ALEWIFE CENTER PROJECT

REVIEW OF TRAFFIC ISSUES

(Notice of Project Change Jan. 1996)

*prepared for the Alewife Study Group
by
Stephen H. Kaiser
February 1996*

..... ROUTE 2 AND ALEWIFE BROOK PARKWAY

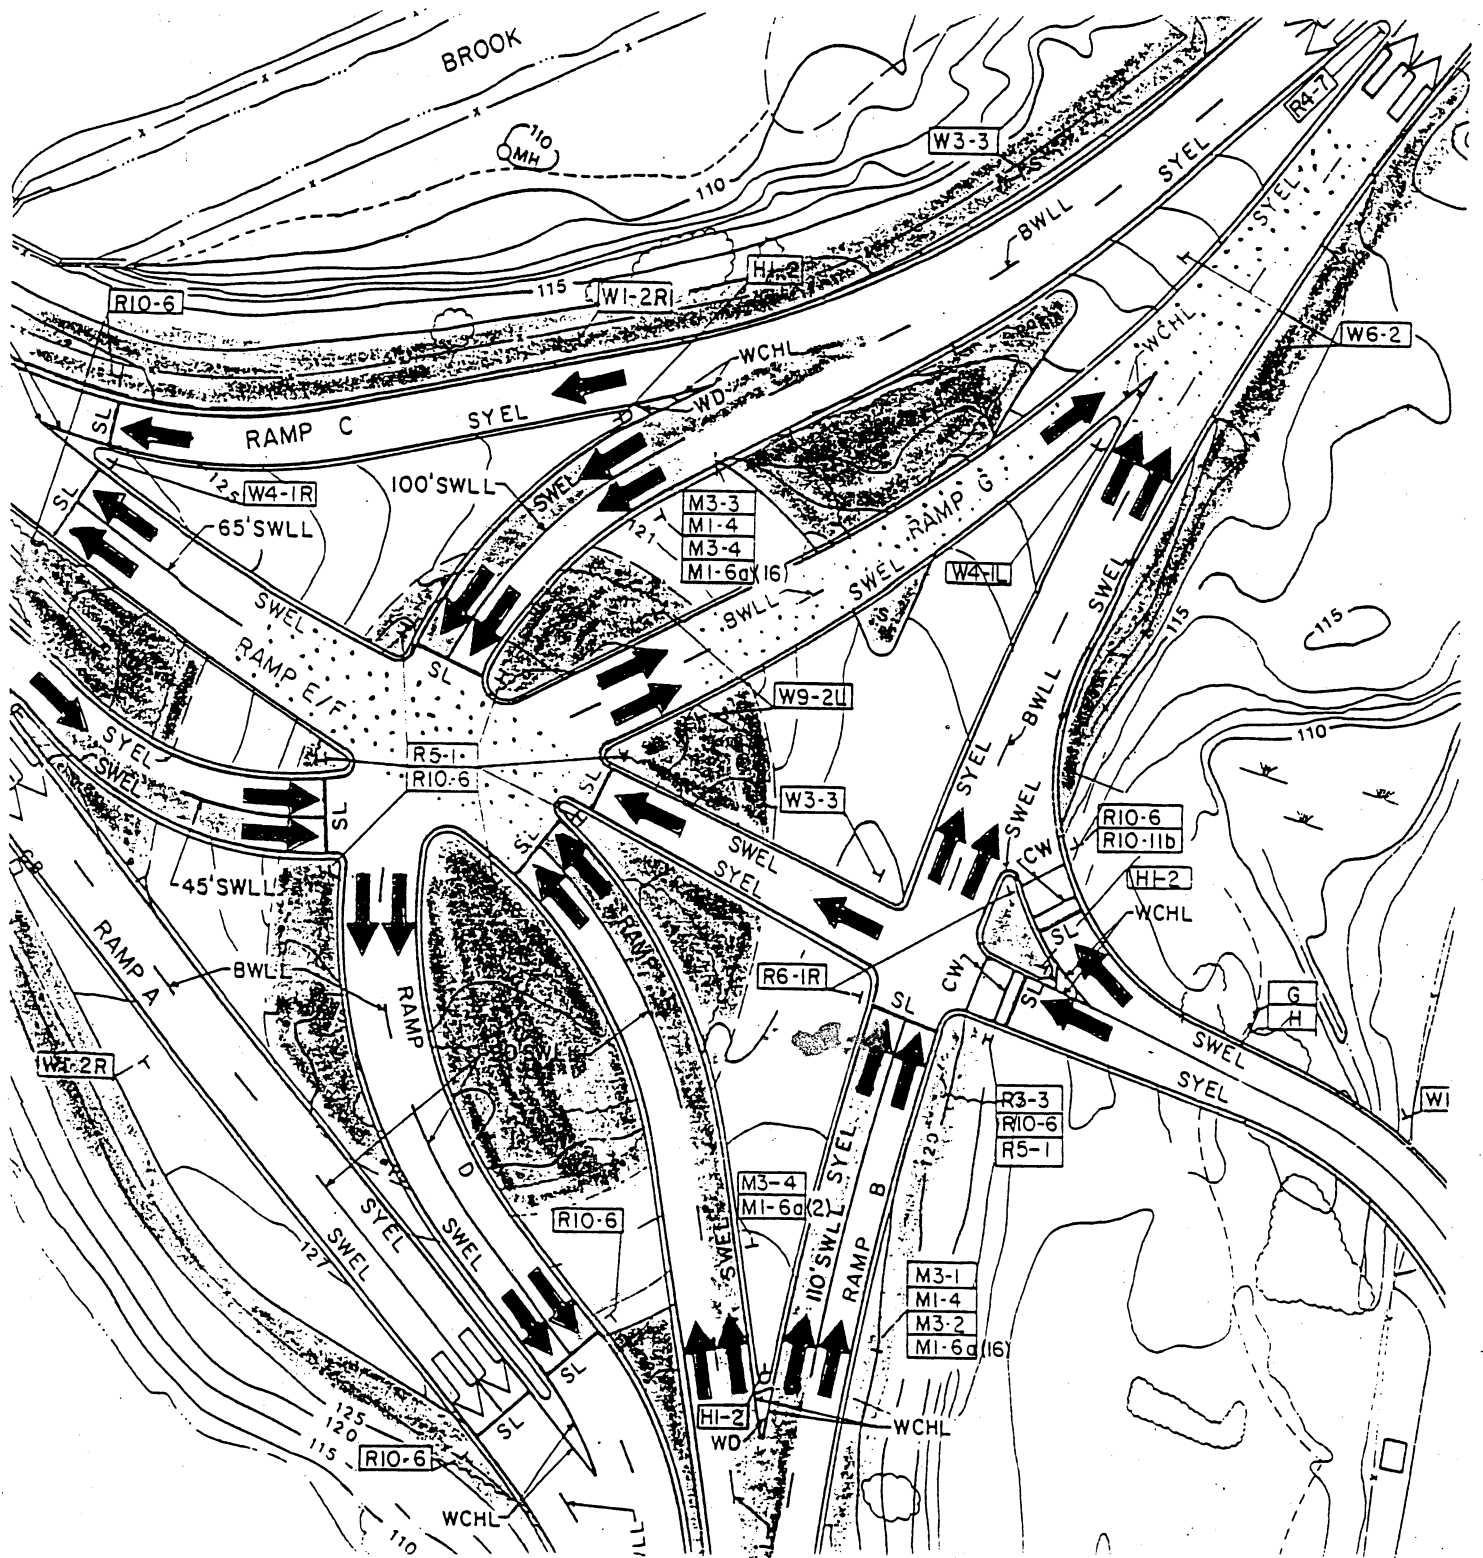
The intersection of Route 2 and Alewife Brook Parkway was first constructed as a rotary in 1933 and was rebuilt in its present signalized configuration in 1985. Based on a comparison of 1985 and 1995 counts, the new intersection carries fewer vehicles than the old rotary and is now clearly the Alewife bottleneck in the afternoon peak hour.

The NPC analysis contends that the critical capacity movements at the intersection are only two -- the outbound parkway flow onto Route 2 and the southbound parkway right turn onto Route 2. The CINCH analysis shows these two moves as critical, in contrast to previous studies which had found the center crossing of three moves plus the ramp as being critical.

The reason why the HCM/CINCH analysis does not show the center three phases as critical is due to several factors :

2. The existing intersection contains four different examples of *short lane* conditions. A short lane means that queuing can occur in a lane for only a short distance before it blocks off another lane. Two short lane conditions apply to the northbound parkway approach and one each to the eastbound and southbound approaches. Any observer watching traffic in the peak hour can see that one *never* gets a good two lanes of flow across the stop line in any of these four situations. In three cases, it is the right lane which is short and often goes underutilized. Only on the northbound parkway movement does the left lane qualify as short and underutilized.

INTERIM ACCESS ROADWAY ROUTE 2 / ALEWIFE

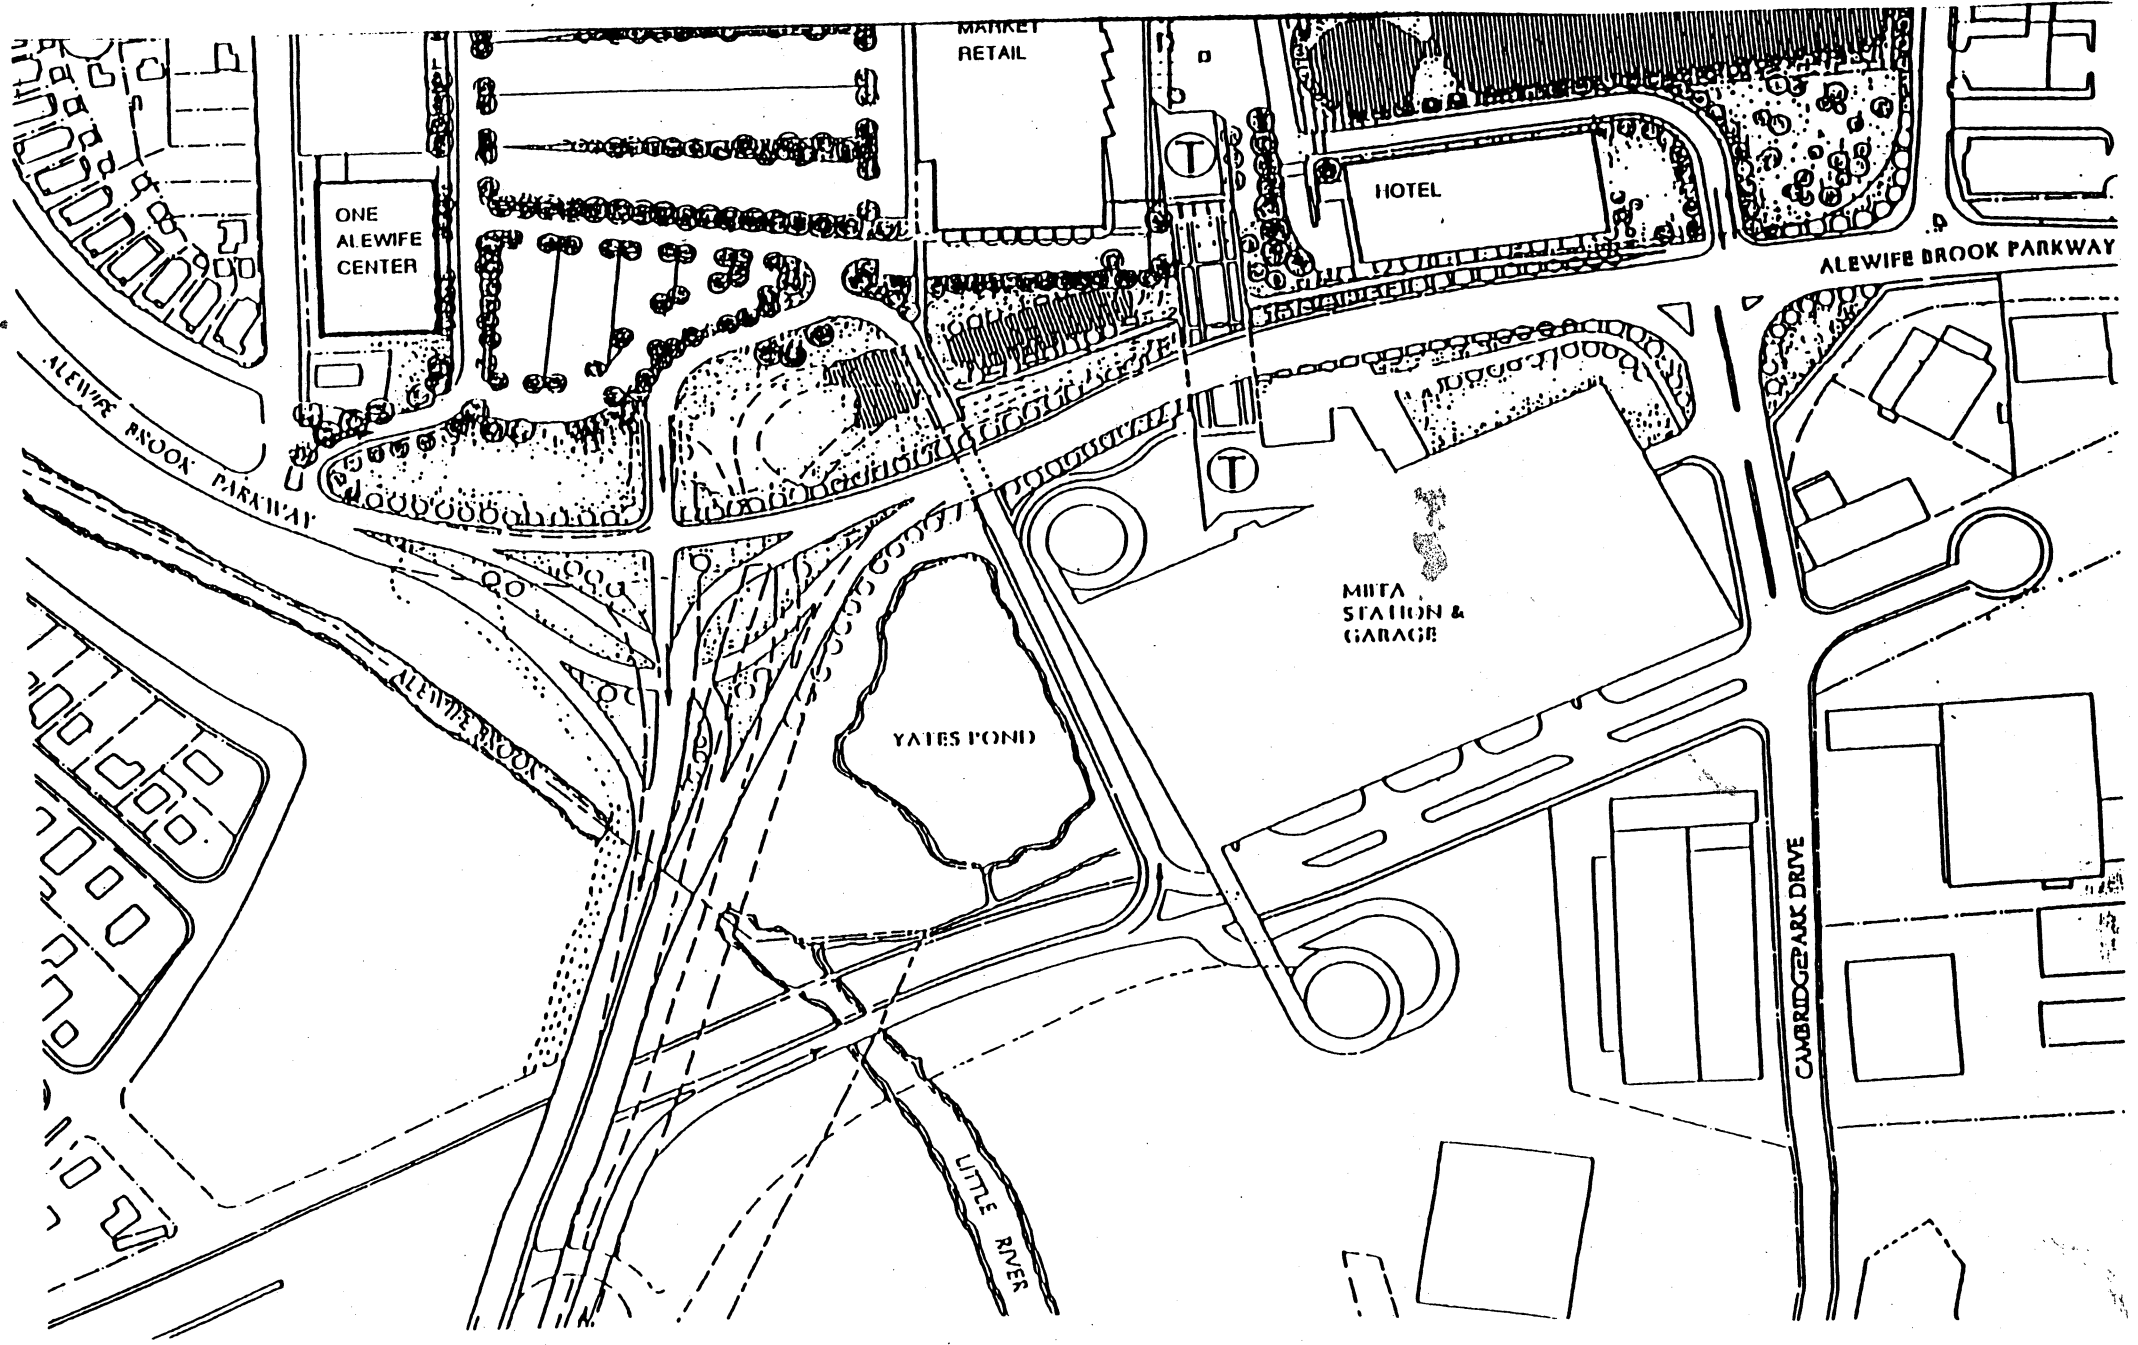
From field measurements, the flow rates through the merge area can achieve a peak of about 2400 vph per lane, before short lane effects reduce the flow rates to 2200 vph overall. This flow implies the ability to process a 4400 vph rate through the merge on green, while the NPC calculations show a capacity of 5483 vph.

There is no discussion in the NPC as to why a study of *existing* traffic should show that capacity is exceeded by 18 %. This result reflects the result of mechanically applying the HCM/CINCH model. It is possible that using older, more traditional analysis methods would have produced a more accurate result.
